MEMORANDUM

DATE: August 19, 2020
TO: Transportation Department Staff
FROM: Andrew Singelakis, Transportation Director
SUBJECT: Interim Update #3 of Standard Drawings

This interim update consists of modifications and additions to the standard drawings for illumination systems as follows:

TYPICAL LUMINAIRE LOCATIONS AND
SMALL WIRELESS FACILITY CONDUIT LAYOUT

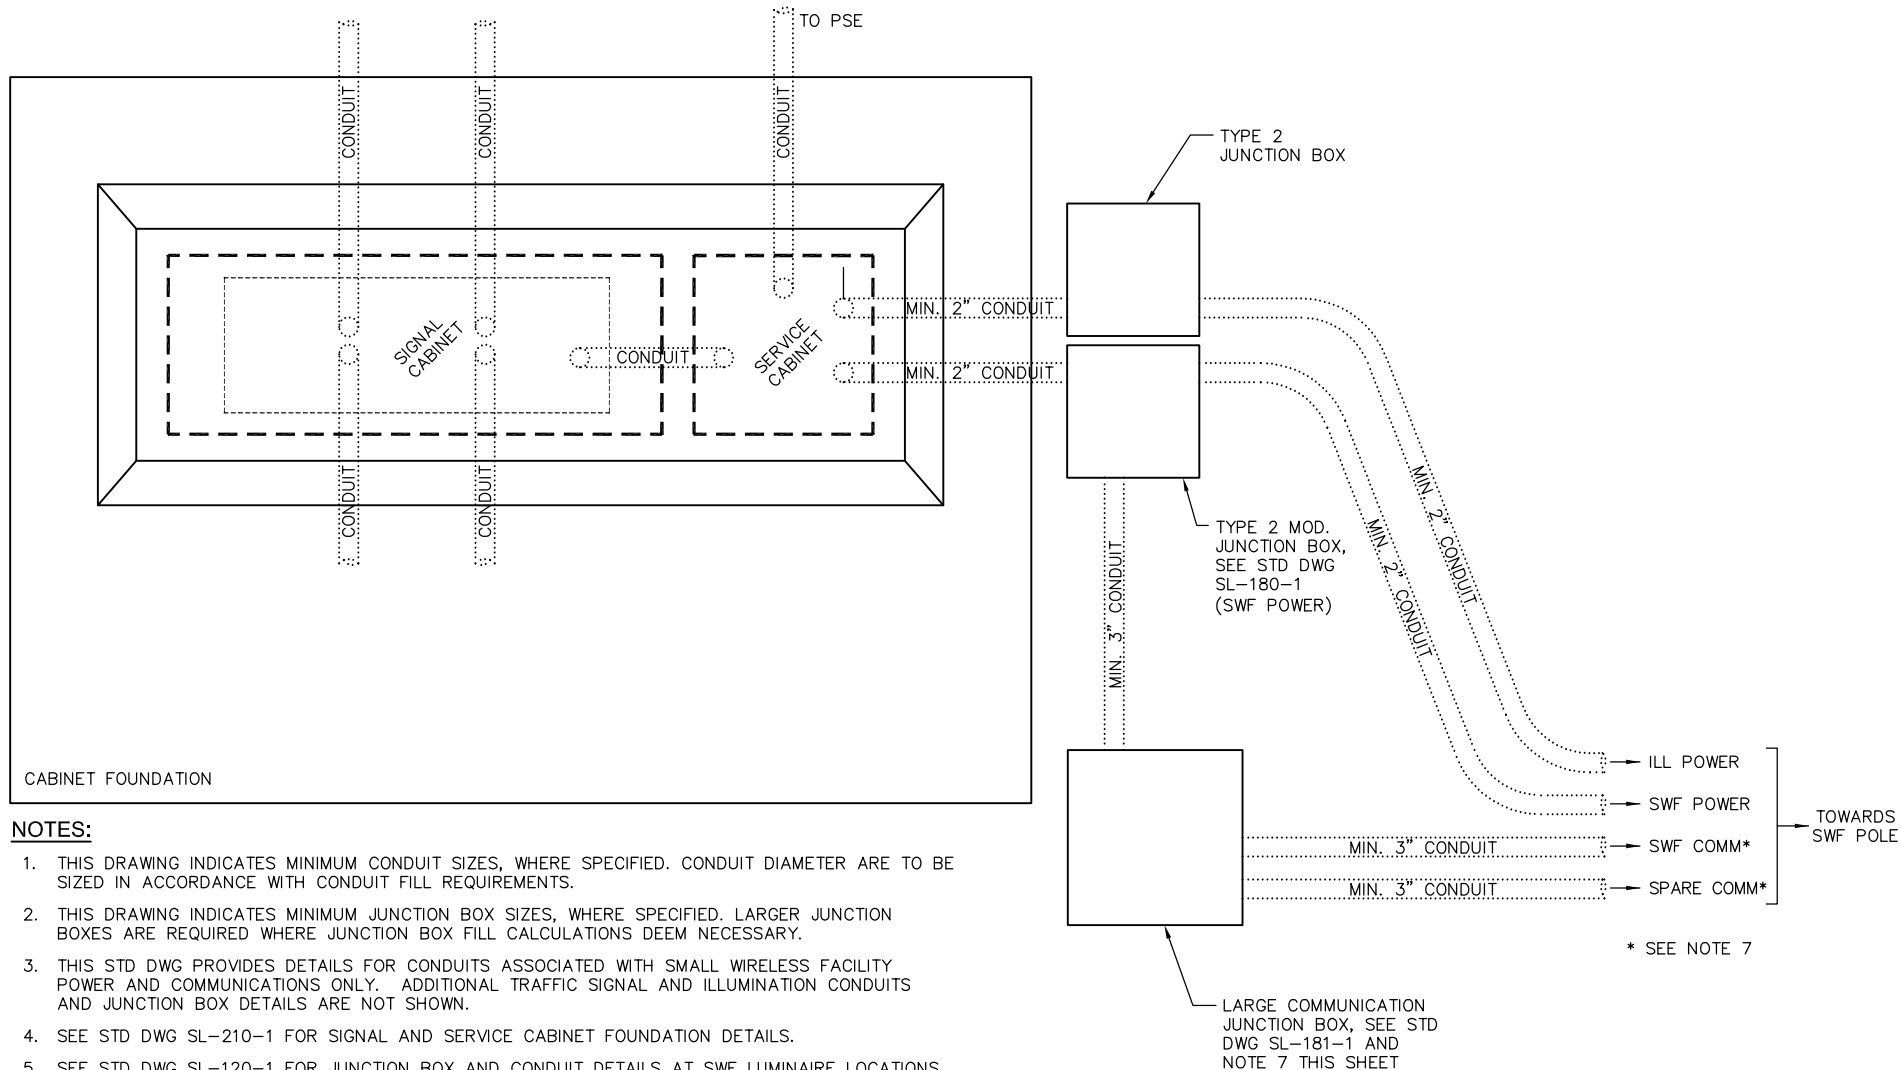
- SL-120-1 Typical Luminaire Locations and Small Wireless Facility Conduit Layout
- SL-121-1 Small Wireless Facility COB-Provided Power Conduit and Junction Box Layout

DRAWING NUMBER	SL-123-1
SCALE	NONE
REVISION DATE	8/20
DEPARTMENT	TRANS

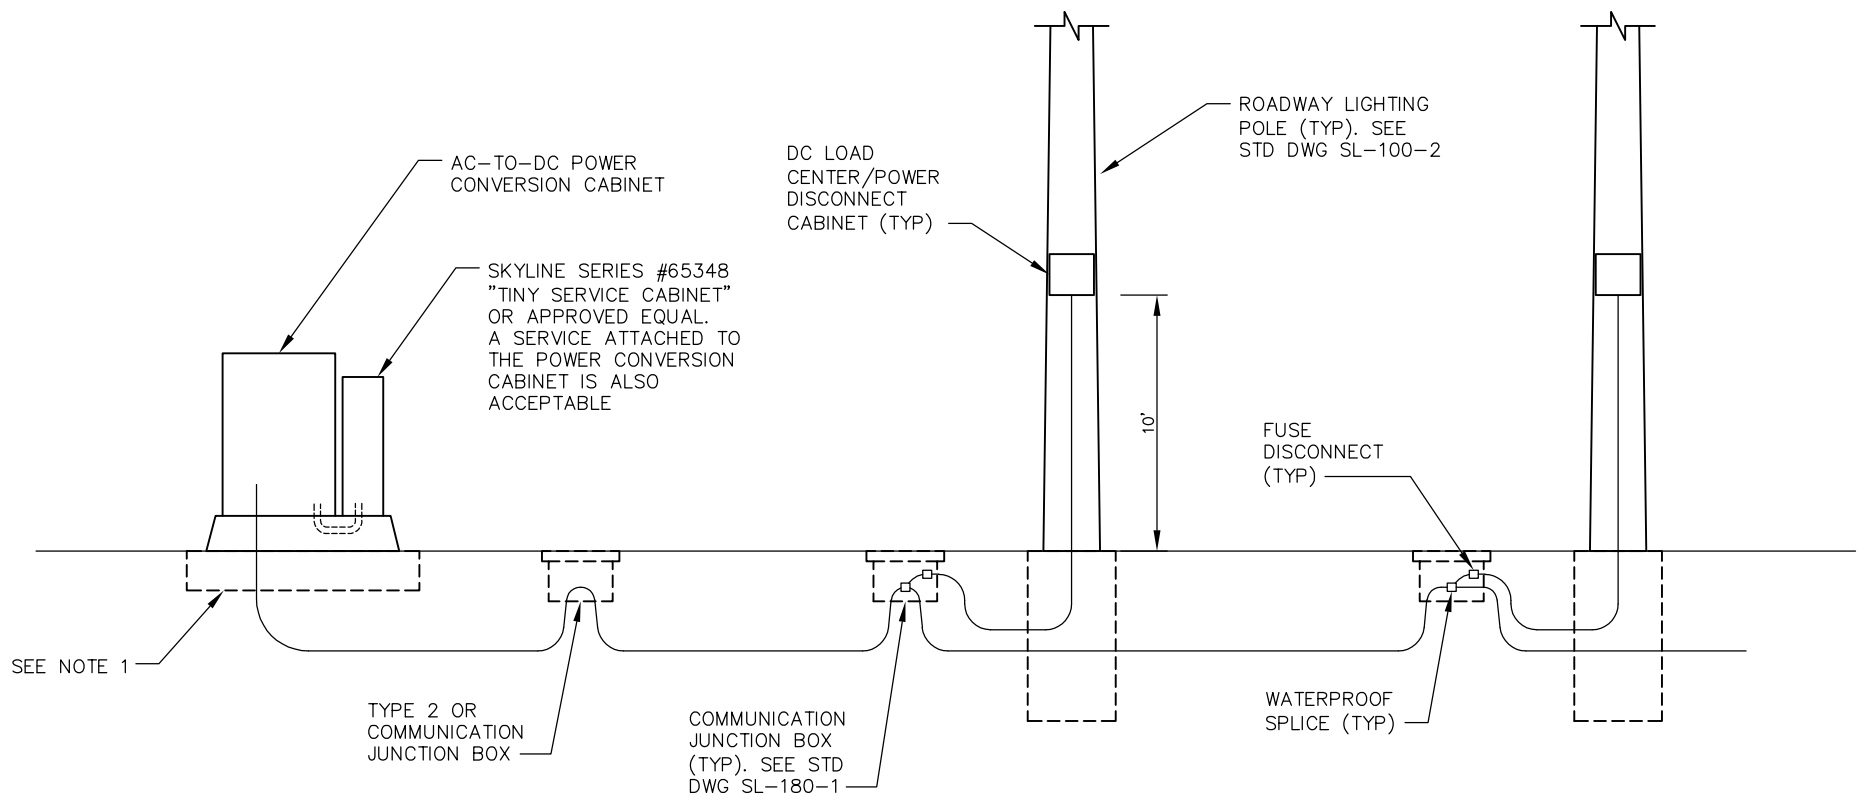
- SL-123-1 Small Wireless Facility DC Power Layout
- SL-124-1 Small Wireless Facility PSE-Provided Service Layout
